MEETING AGENDA

Appearance Commission

Village of Homewood

A. **Public Meeting** for Case 25-28: Appearance Review for Target, 17605 Halsted Street

TRASH ENCLOSURE PLAN
NOT TO SCALE

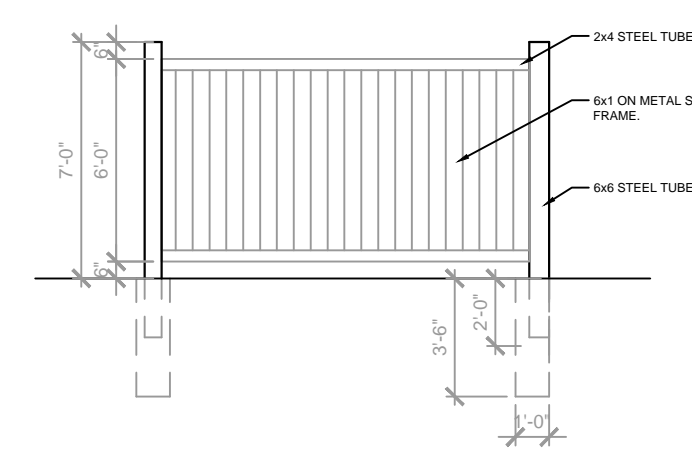
- 3. Parking Island:** Move the existing parking island to a location adjacent to the trash enclosure to provide screening for the enclosure, which meets Zoning Ordinance requirements (Section 44-08). *Staff recommends that Appearance Commission approval by conditions upon the movement of the parking island, the parking space closest to the proposed enclosure.*
